**DM12 Upstate Hodge Center
Arena Humidity Correction
University of South Carolina - Upstate**

Project # H34-9543-JM

Addendum No. 1

DATE: November 7, 2013
FROM: PERITUS ENGINEERS & ASSOCIATES, INC.
TO: ALL BIDDERS

SHEET NO. SKM-4
OF 5

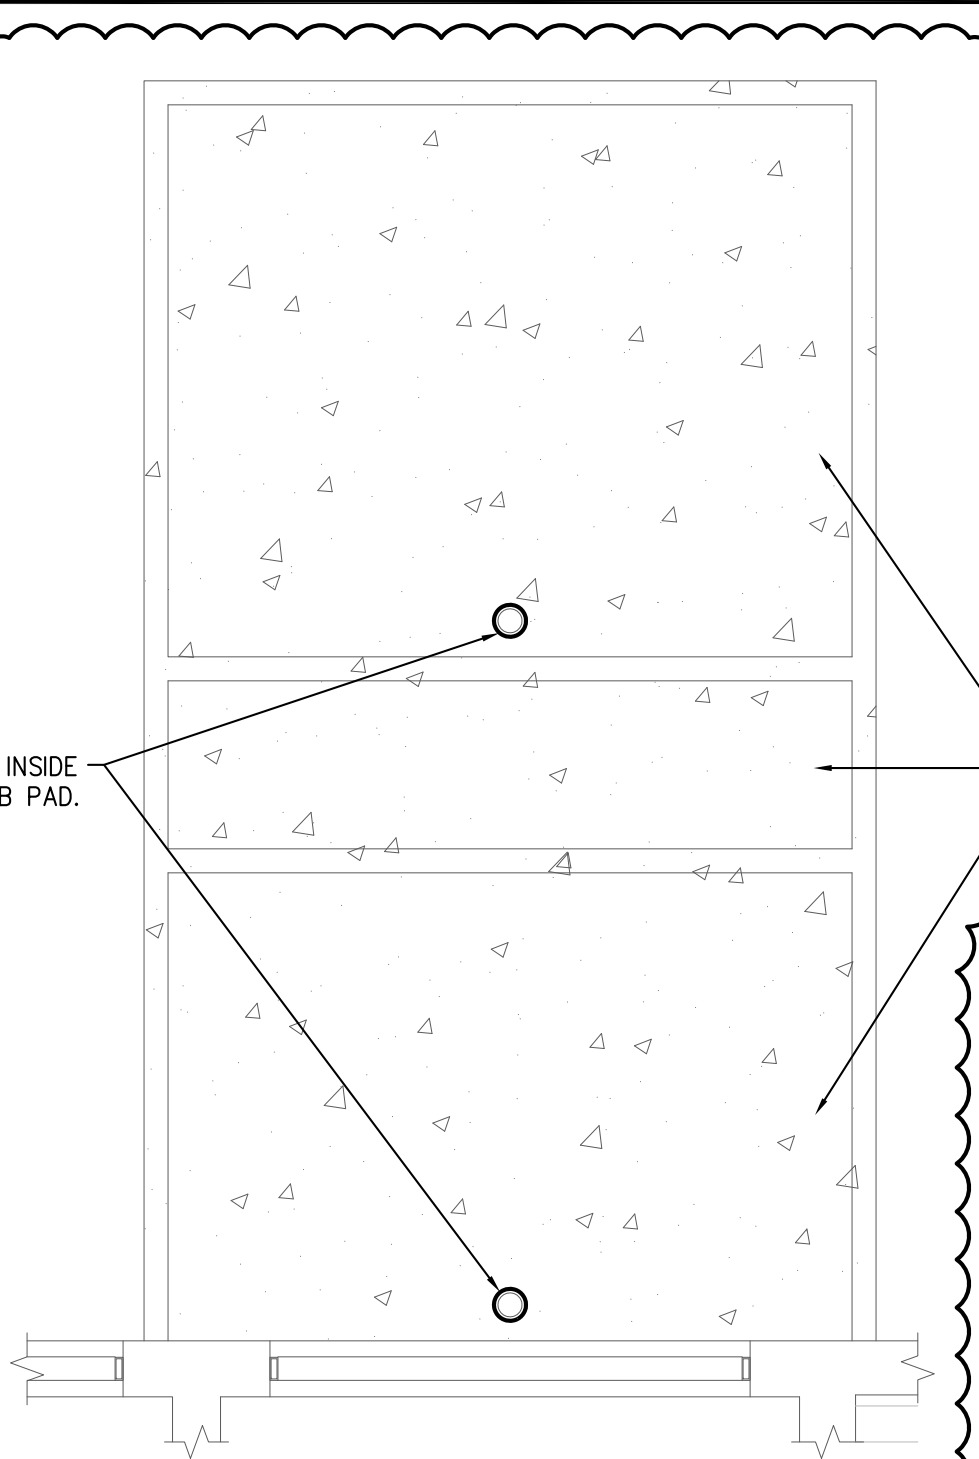
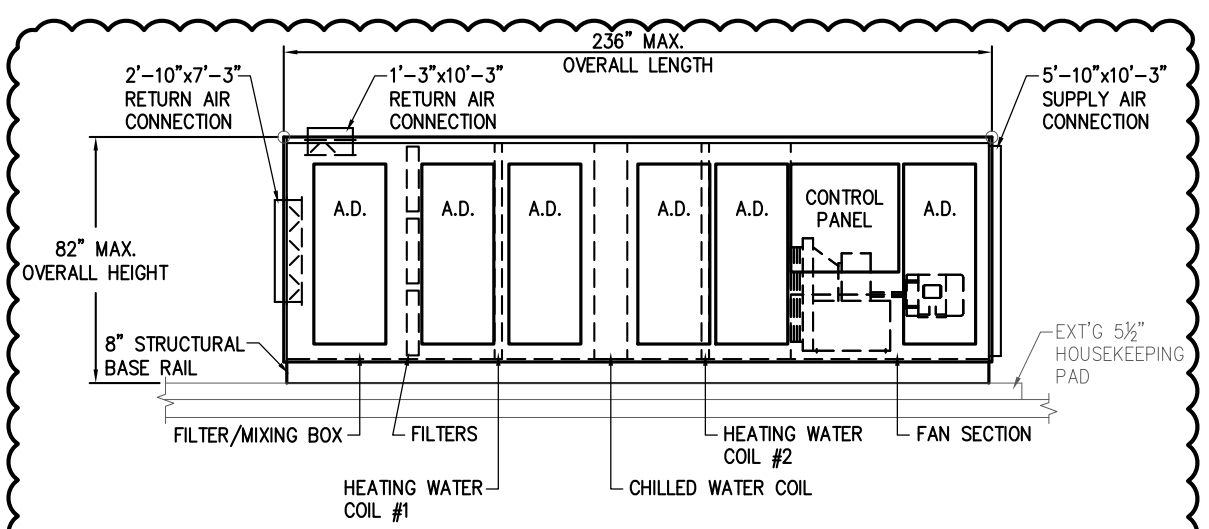
Question #5: The spec. indicates in 2.02.D.1 that "Units shall have overall dimensions as indicated and fit into the space available with adequate clearance for service". There is no where on any of the documentation that I received that gives the unit dimensions, unit max. dimensions, or the max. section sizes for the unit sections to get into the building (since this is an indoor unit). On drawing M-1 there is a room plan view and a separate elevation view but the elevation view states "No Scale" and it is not known if the plan view is to scale. We need Unit Dimensions and need to know if the sections are going through a fixed opening and what size that opening is.

Response to Question #5: Included with Addendum # 1 are clouded revisions to drawing M-1 to indicate dimensional requirements of AC-1.

NEW AC-1 DETAIL
NO SCALE
INDIVIDUAL SHIPPING SPLITS ALONG LENGTH OF NEW AC-1 AS REQUIRED TO ENTER MECHANICAL ROOM 94" WIDE DOOR OPENING (WITH DOORS REMOVED). OVERALL WIDTH OF NEW AC-1 NOT TO EXCEED 129"
